DEVELOPMENT SERVICES ENGINEERING PLANS REVIEW

LEGAL ADDRESS: 1501 Alton Road

PLAN DESCRIPTION: Financial Institution (Savings of America)

SAVINGS OF AMERICA
ALTON ROAD BRANCH
MIAMI BEACH, FLORIDA

Grading Plan

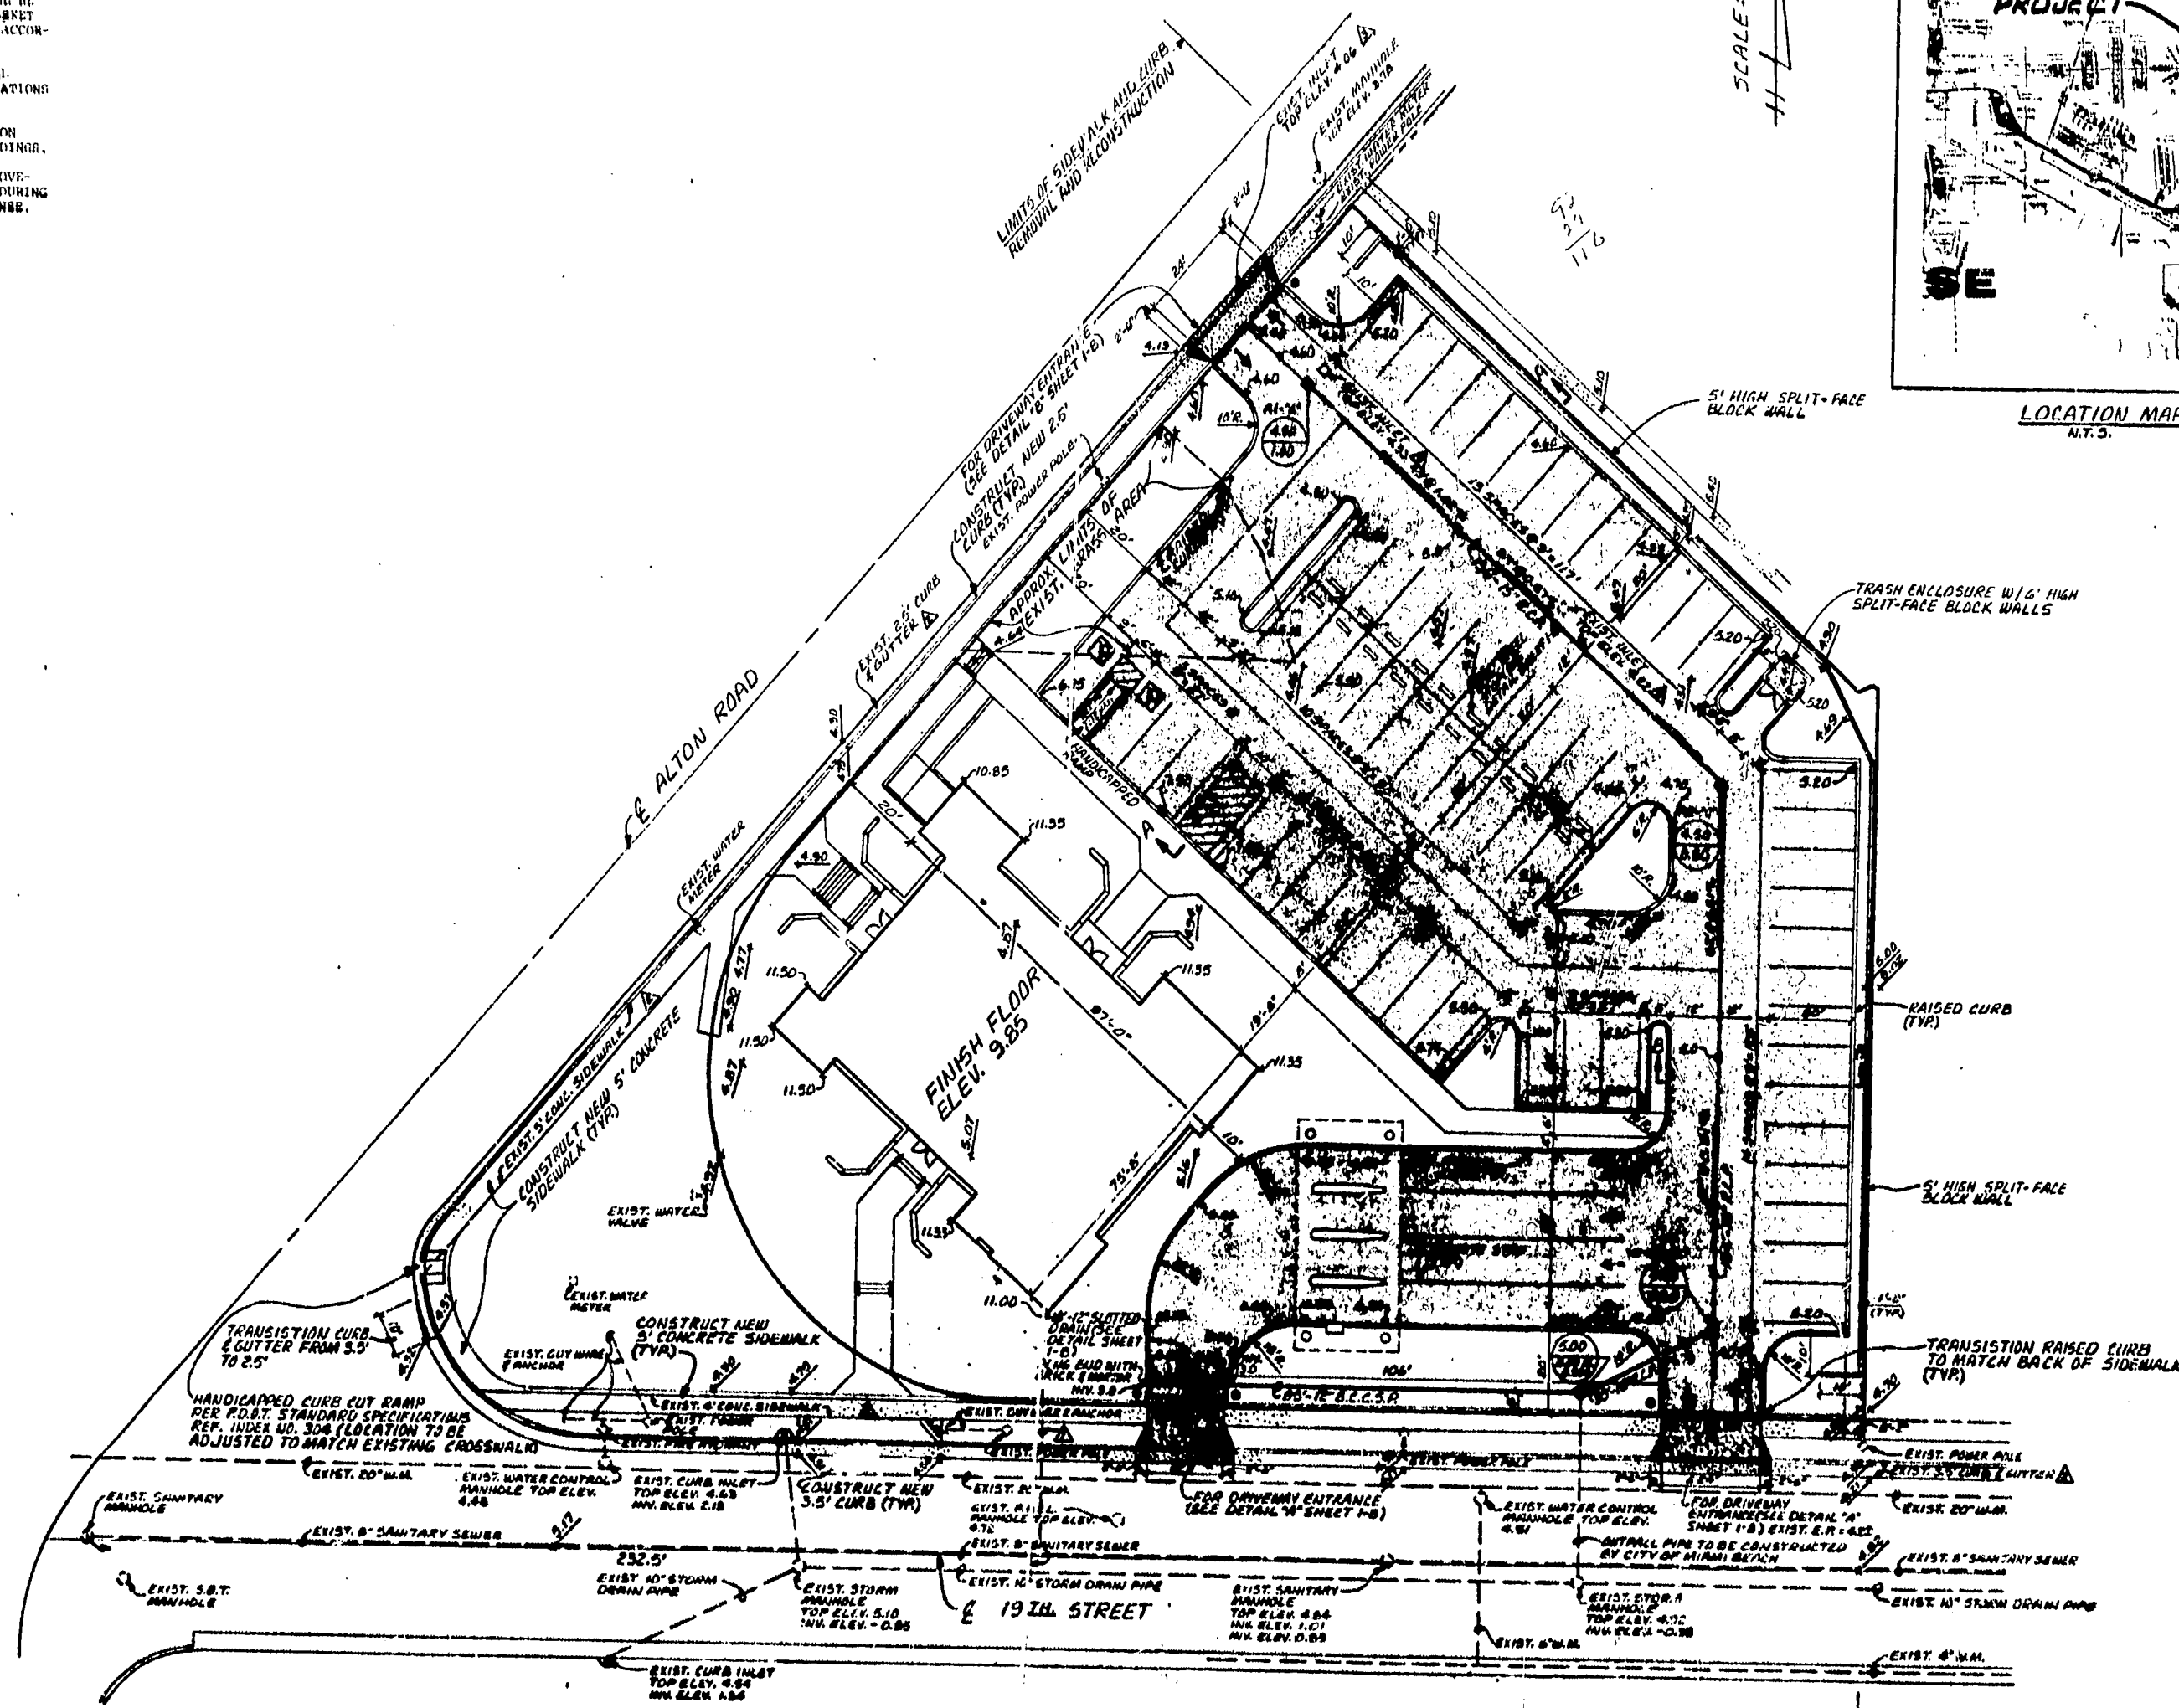
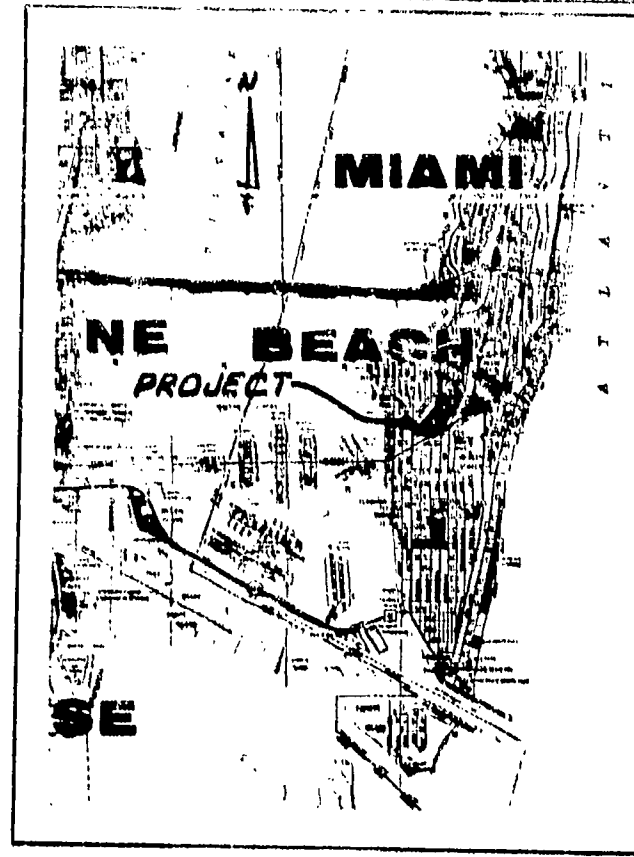
GARBAGE FACILITIES: Trash enclosure as shown

SANITARY SEWER: To use existing facilities-to be field checked by Public Works. Garbage disposal units not permitted.

WATER: See Note #1

DRAINAGE: See Note #2
Side yards to be sloped so as to not shed water to neighboring properties. A/C condensate to be piped to sewer drainage well to be located on private property.

GRADES: To meet Federal Flood Insurance criteria of +9.00 MSL (+9.85 U.S.L.L., Bay Datum)

COMMENTS: Public Works Department Street permit required for work done on city property.

Note #1 - Cost for water service
1" water meter and tap - \$600 + \$50 = \$650.00
1 1/2" water meter and tap - \$840 + \$60 = \$900.00

Note #2 - Public Works Dept. to estimate cost for extending storm pipe from manhole to property line.
